ENVIRONMENTAL ASSESSMENT

Discharge of Condition Package

The Green House Sussex Ltd, Lake Lane, Barnham,
West Sussex, PO22 0AD

Our Ref: 5877_DowsettMayhew_Lake Lane

SEASONAL WORKERS ACCOMODATION
FOUL AND STORM DRAINAGE

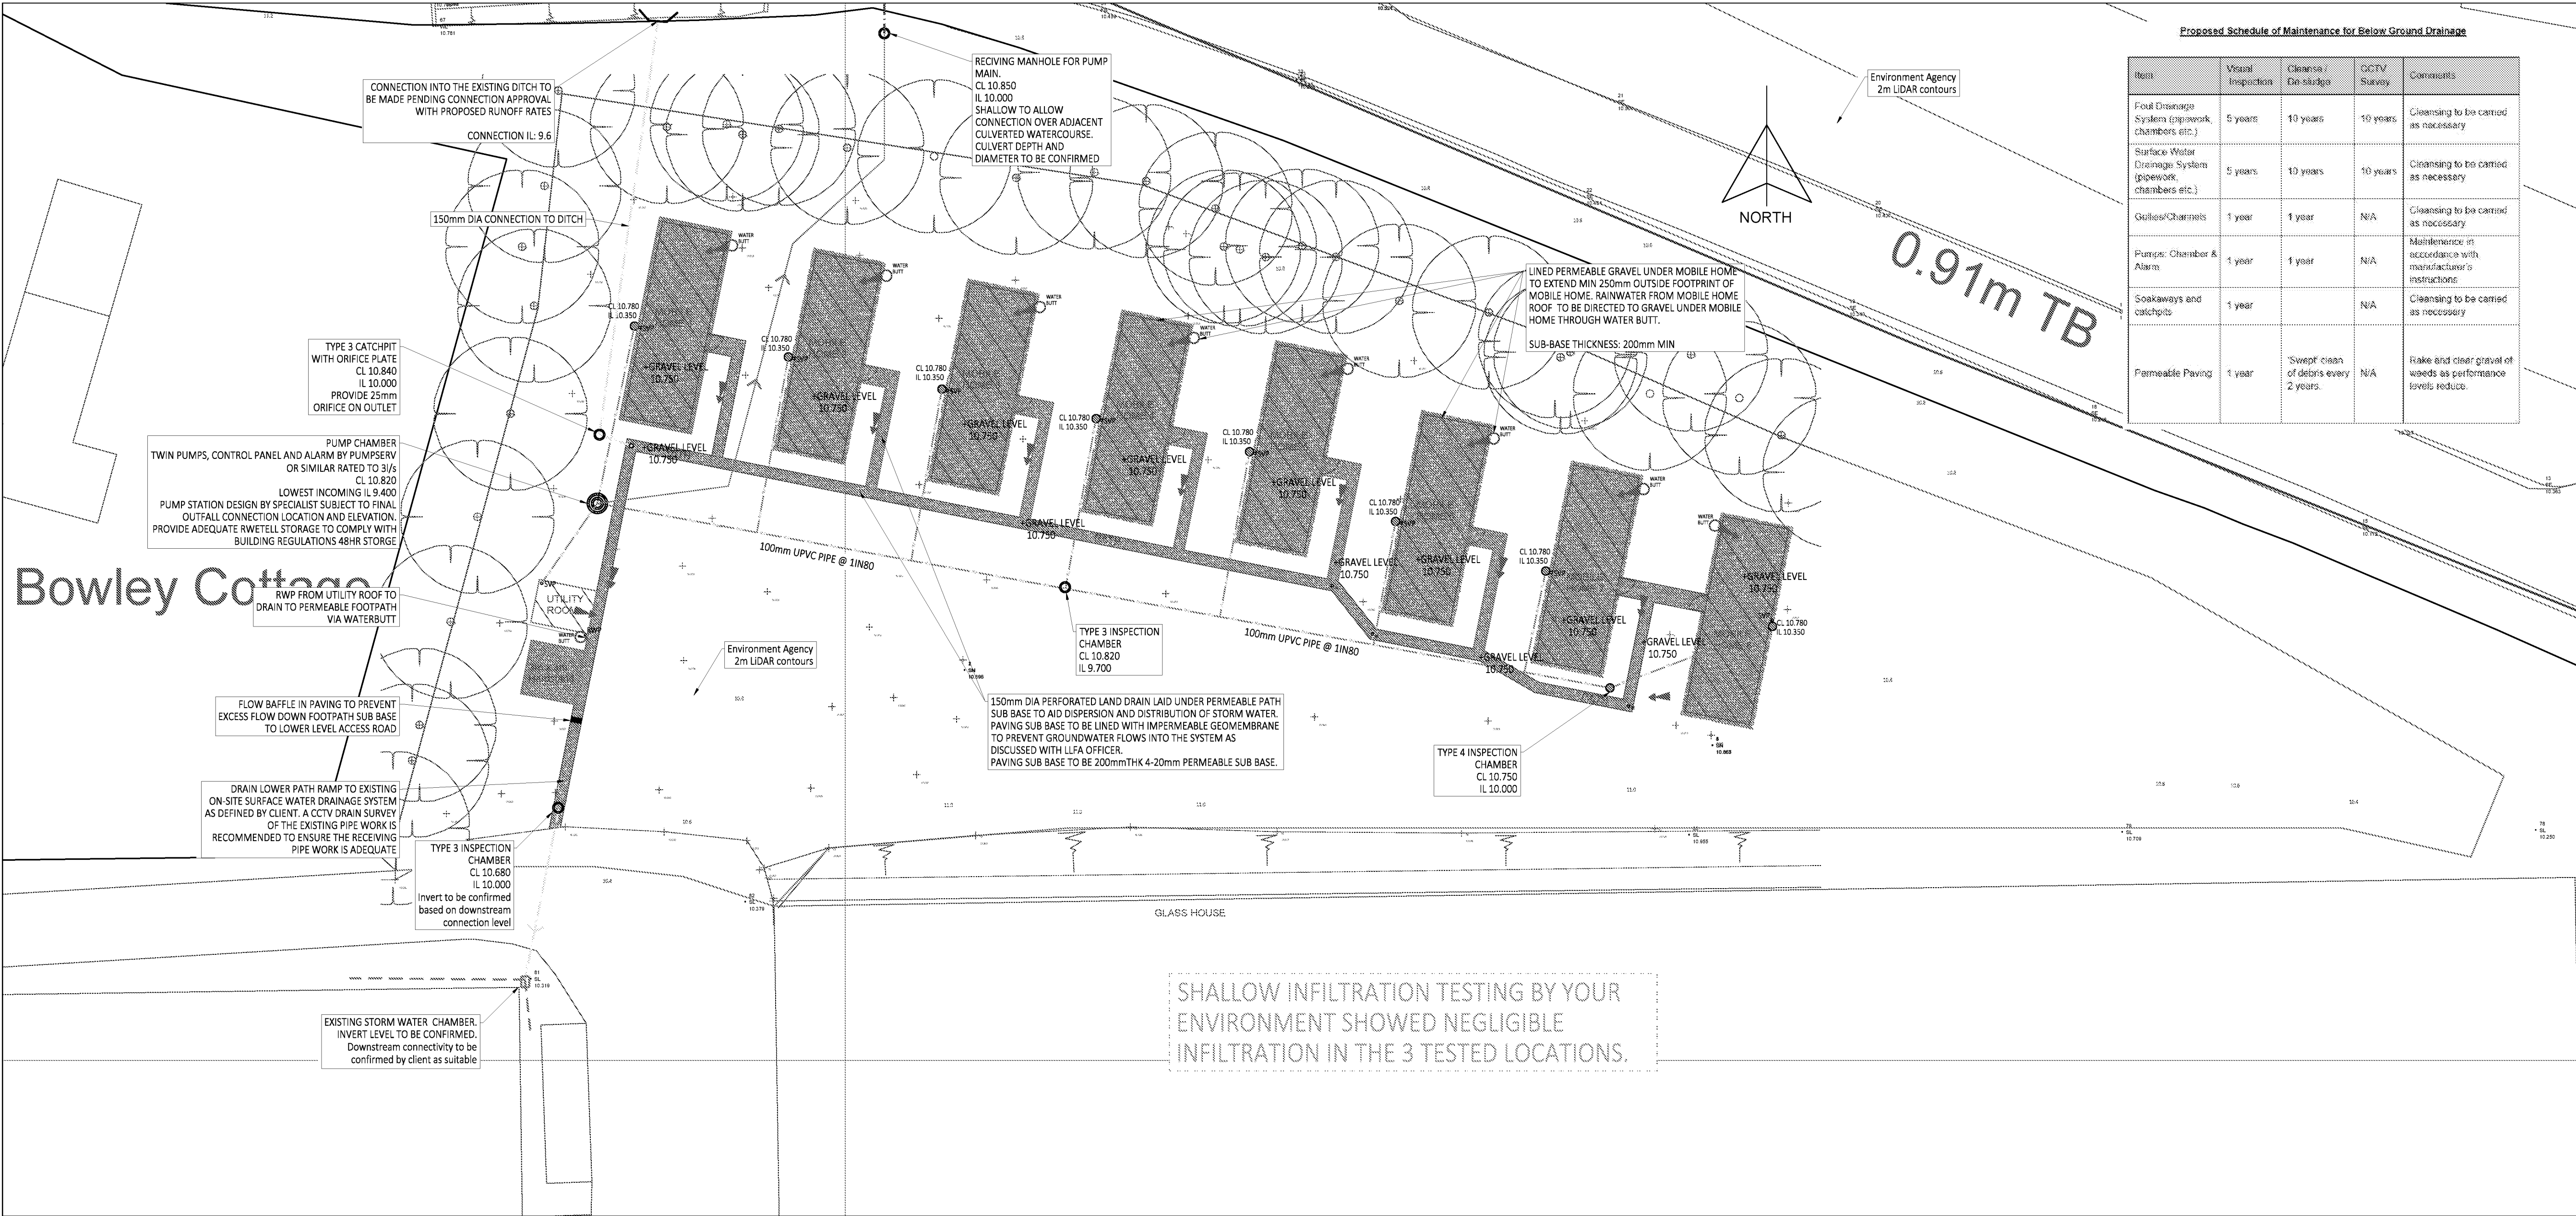
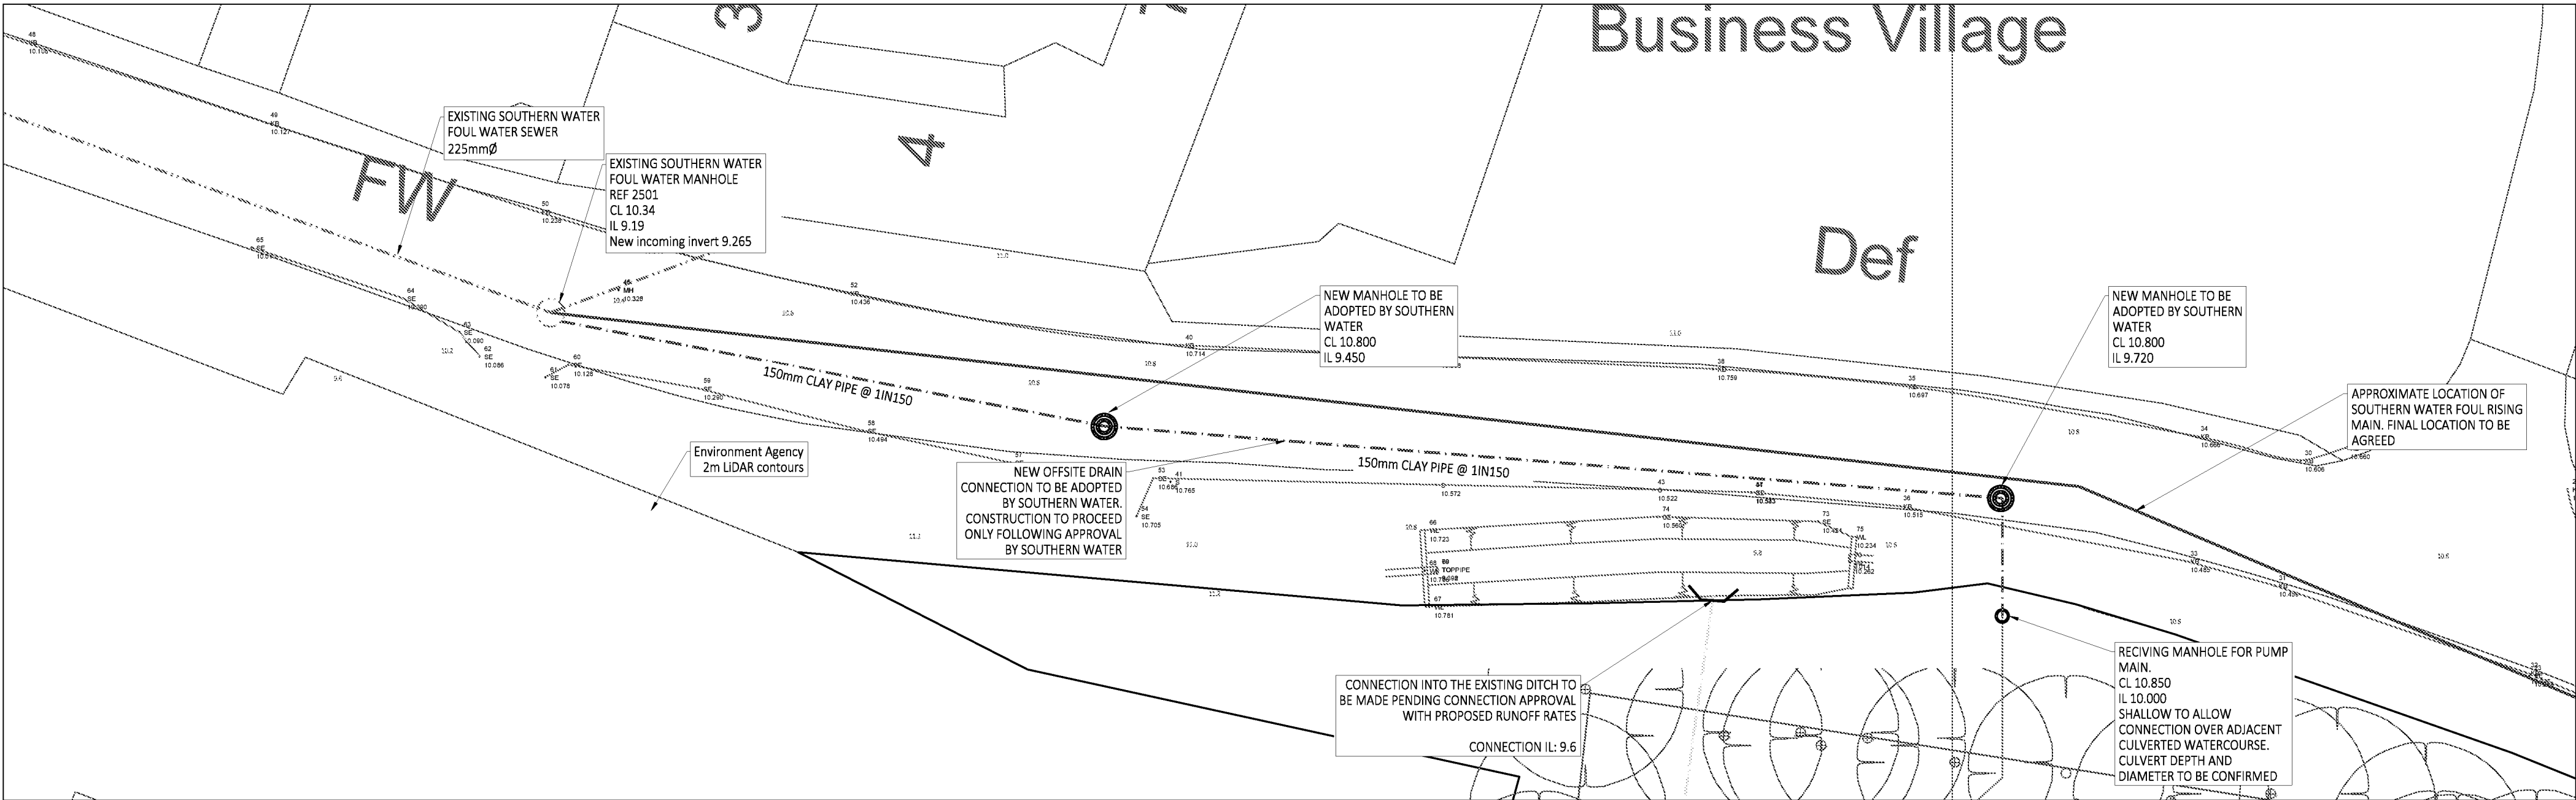
2.1 On 13.06.2021, the LLFA provided the following response to the previous proposals:

1. *The applicant has completed summer infiltration testing which indicate infiltration is not viable.*
2. *No winter groundwater monitoring results have been provided, this information must be supplied to evidence that groundwater will not get into the surface water drainage system.*

3. *The proposal is for an unlined system to be pumped. This could in winter result in groundwater being pumped.*
4. *Pumping is not supported, it is not a sustainable solution. Pumps also fail and can result in increased flood risk both on and off site. The applicant must submit a revised gravity scheme.*

5. *The proposals are to pump surface water to the on site reservoir. The statement claims that no surface water will be discharged off site. No evidence has been submitted to evidence that either the existing surface water drainage network or reservoir have the capacity to accept these additional flows. The reservoir must also have an overflow to somewhere for water to be discharged in times of exceptional rainfall when irrigation demands are less, i.e. the winter. Therefore the statements provided are not supported by ourselves.*

It is not possible for us to recommend discharge of this condition at this time with the strategy presented. A fully revised surface water drainage design is required, which may involve a gravity outfall to watercourse.

I have considered this further and I do not believe that the benefit gained from water reuse is sufficient to outweigh the negatives of pumping in this instance. Therefore, please look into forming a gravity solution to the watercourse.

- The permeable gravel is proposed to be lined with an impermeable geomembrane.
- The surface water connection from the site is proposed to be a gravity connection to the open watercourse north of the site.

3	08.09.22	MB	Amended to show offsite gravity sewer connection to ditch and lined permeable gravel
4	15.06.21	MN	Amended to show offsite connection and pumped storm water
